February 22, 2017

SUBJECT: FINAL SAFETY EVALUATION FOR GE HITACHI NUCLEAR ENERGY - AMERICAS, LLC TOPICAL REPORT NEDE-33005P AND NEDO-33005, REVISION 0, "LICENSING TOPICAL REPORT TRACG APPLICATION FOR EMERGENCY CORE COOLING SYSTEMS / LOSS-OF-COOLANT-ACCIDENT ANALYSES FOR BWR/2-6" (CAC NO. ME5405)

Enclosure:  
Final SE (Non-Proprietary)

Figure 2. MELLLA+ Power-to-Flow Operating Domain.

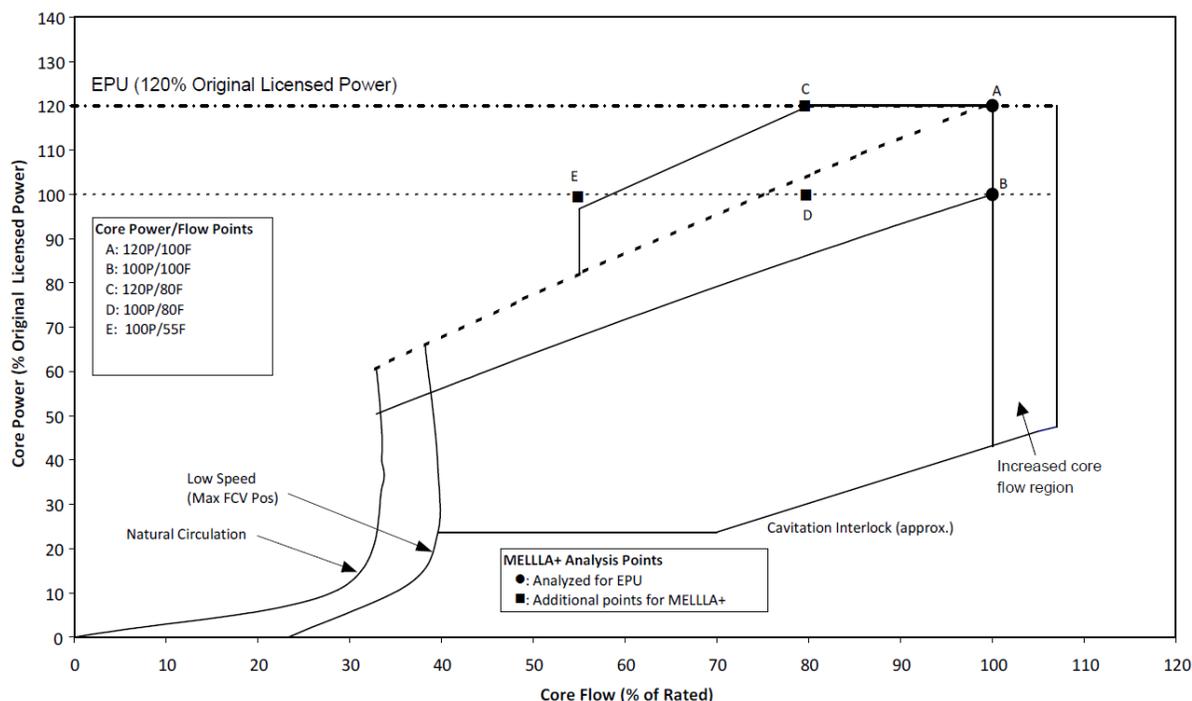
<p>Section 5.2 Operating Statepoints</p>	<p>Page 21: The figure should be cited from the MELLLA+ LTR and referred to as typical since some plant-specific maps are different.</p> <p>GEH suggests the following change (Line 5): <u>A typical</u> <del>The</del> MELLLA+ operating domain is illustrated <u>in Figure 1-1 of Reference 58</u> <del>Figure 2</del>.</p> <p><i>Suggested change shown in the markup.</i></p>	<p>The figure in question is a reproduction of Figure 6.2-1 of NEDE-33005P. Since the figure was obtained from the LTR that is the subject of the SE, the NRC staff retained the figure as-is.</p> <p>The proposed change is modified as follows: A typical <del>The</del> MELLLA+ operating domain is illustrated in Figure 2, which is a reproduction of Figure 6.2-1 of NEDE-33005P.</p>

Location	GE Comment	NRC Disposition
<p>Section 5.2 Operating Statepoints</p>	<p>Page 21: The figure should be cited from the MELLLA+ LTR and referred to as typical since some plant-specific maps are different. If the figure is retained, then a better figure is needed since the figure in the SE has Points D and E misaligned.</p> <p>GEH suggests the following change (Line 7): Replace Figure 2 with Figure 1-1 from Reference 58.</p>	<p>The figure in question is a reproduction of Figure 6.2-1 of NEDE-33005P. Since the figure was obtained from the LTR that is the subject of the SE, the NRC staff retained the figure as-is. Change not accepted.</p>
<p>Section 5.2 Operating Statepoints</p>	<p>Page 21: If Figure 1-1 from Reference 58 replaces the existing Figure 2, then the points analyzed for MELLLA+ plants needs to be revised.</p> <p>GEH suggests the following change (Line 11): points <u>A-B, D, and E</u> in Figure 2. <i>Suggested change shown in the markup.</i></p> <p>Note that if the existing Figure 2 is not replaced, then the points should be A, C, and E.</p>	<p>The figure contained in NEDE-33005P was retained in the SE (i.e., existing Figure 2 was not replaced); therefore, the GEH suggestion to identify Points A, C, and E was considered by the staff. As noted on Page 71 of the SE, the applicable requirement for MELLLA+ is to analyze, “the rated EPU [extended power uprate] power/rated CF [core flow], rated EPU power/minimum CF, and the low-flow MELLLA+ boundary (Transition Statepoint). These correspond to Points A, C, and E, on the figure. Therefore, the NRC staff agrees with this suggested change because it is consistent with the MELLLA+ analytic requirements.</p> <p>The proposed change is modified as follows: points A, C, and E in Figure 2.</p>
